Docket Item # 4
BAR CASE # 2009-0232

BAR Meeting
October 28, 2009

ISSUE: Awning, Signage and Alterations
APPLICANT: Café Nicole at Parker Gray (Nicole Burlimann, Applicant)
LOCATION: 1125 Queen Street
ZONE: CL / Commercial Low Zone

Figure 3. Proposal

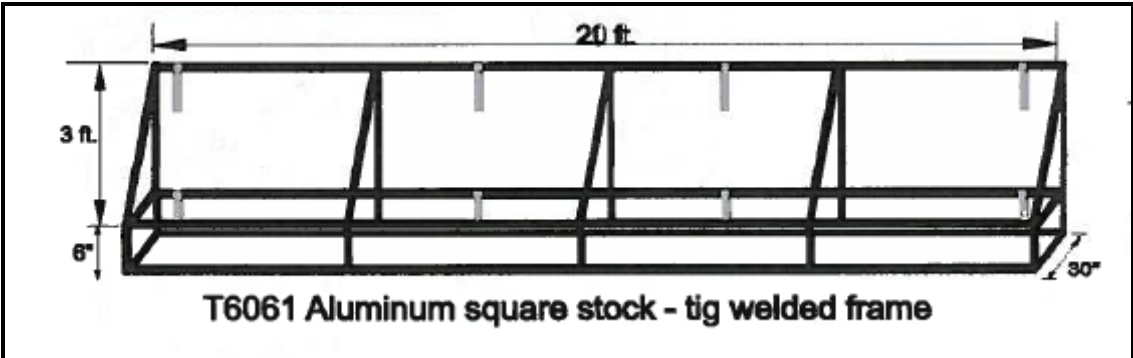
The applicant proposes a new, three foot (3') high by 2-1/2 feet wide by twenty feet (20') long awning to be installed above the existing windows on the building's south (front) elevation. The awning will be fabricated of an aluminum square welded frame, wrapped with blue, Sunbrella fabric. The awning's frame supports will be affixed to the brick façade through the wall surface's mortar joints with sixteen (16), ½ inch by four inch (4") lag and shield bolts. The proposed color scheme for the oval, two foot (2') by four foot (4') sign to be located in the center of the awning is a white background with red and blue lettering identifying the restaurant name “Café Nicole Restaurant.”

A new, flat sign is proposed to be mounted on the west side elevation of the building. The proposed two foot (2') by four foot (4') oval-shaped sign will be fabricated of MDO Plywood with applied surface graphics. The proposed color scheme for the sign is consistent with the awning sign with a white background and blue and red graphics which identify the restaurant name “Café Nicole Restaurant.”

The applicant proposes to mount the sign toward the southern edge of the storefront's west (side) elevation.

Since the original submission, the applicant has worked with staff to modify the design of the sign and awning to reduce the amount of text on the sign and provide a proposal that is more in-keeping with the Board's practices. To this end, the original submission for a white and blue striped awning was altered to the current design for a solid blue awning. Additionally, the applicant's logo was originally presented with the additional wording "at Parker Gray." Staff recommended that these words be deleted from the logo as the Board has a general policy not to include historic district or City names in the signage.

Figure 4. Awning Frame Detail

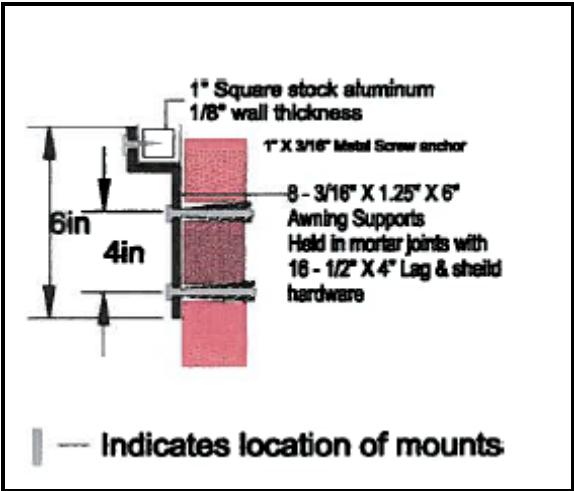
C-1 Awnings must comply with all applicable requirements of USBC 3105.3 and 3202.3.1 Retractable and fixed awnings must have a minimum 7 foot clearance form a sidewalk to the lowest part of the framework or any fixed portion of any retractable awning is required. Retractable awnings must be securely fastened to the building and can not extend closer than 24 inches in from the curb line (USBC 3202.3.1).

C-2 Fixed awnings must be designed and constructed to withstand wind or other lateral loads and live loads required by the USBC. Structural members must be protected to prevent deterioration (USBC 3105.3).
